CERTIFICATE OF APPROPRIATENESS

Applicant: Sam Gianukos, agent for Sarah Overstreet, owner

Property: 609 Harvard Street, Lot 10, Block 277, Houston Heights Neighborhood Subdivision. The property includes a historic 1500 square foot, one-and-a-half-story single-family residence and detached garage situated on a 6,600 square foot (50' x 132') interior lot.

Proposal: Alteration – Addition, Windows

Eave Height (Addition and New Construction)

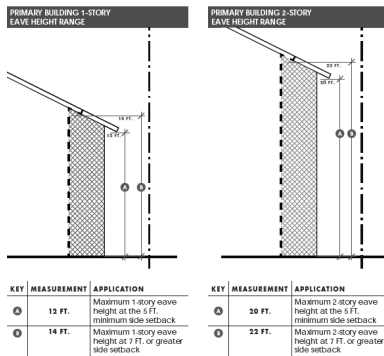
Proposed eave height: 24'- 0"
 - The proposed eave height is higher than the max specified in the guidelines measurable standards but is needed to meet the roofline of the existing house at the rear to accommodate the second-floor addition. The existing ridge height is 24'-2", and the proposed ridge height is 29'-6".

Building Wall (Plate) Height (Addition and New Construction)

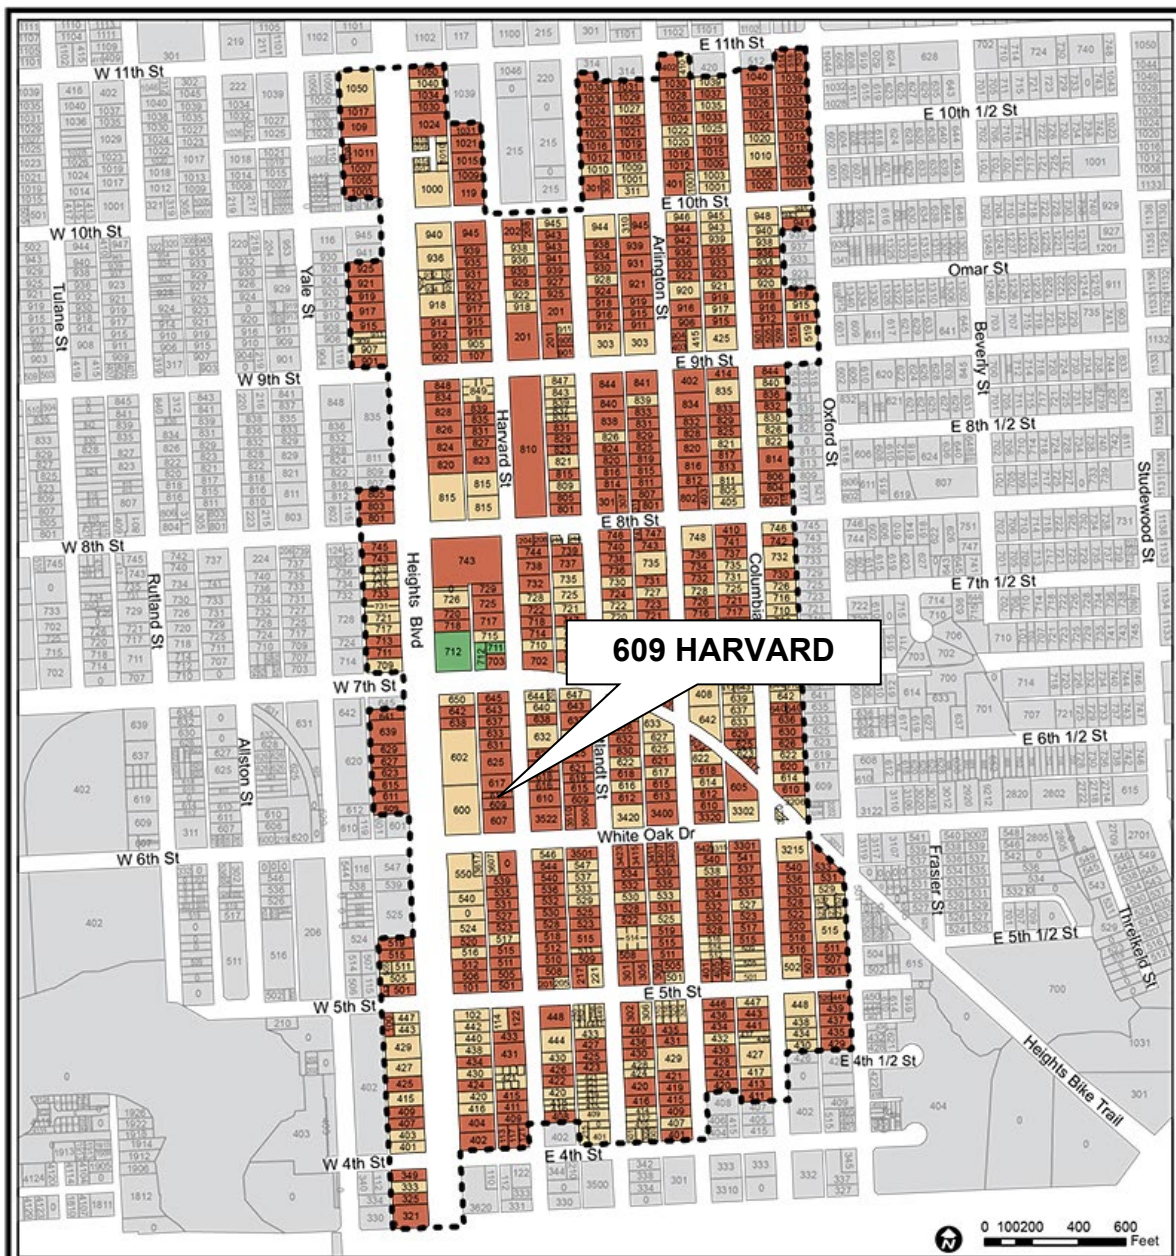
Proposed finished floor: 3'-2" to match existing
 Proposed first floor plate height: 9'-0" to match existing
 Proposed second floor plate height: 10'-0" to align with the current roofline. While the proposed 2nd floor plate height is higher than the max specified in measurable standards, it is due to modifications previously done on the interior of the house that require a higher plate height to level the new addition. This is an unusual circumstance, but is necessary for maintaining the existing.
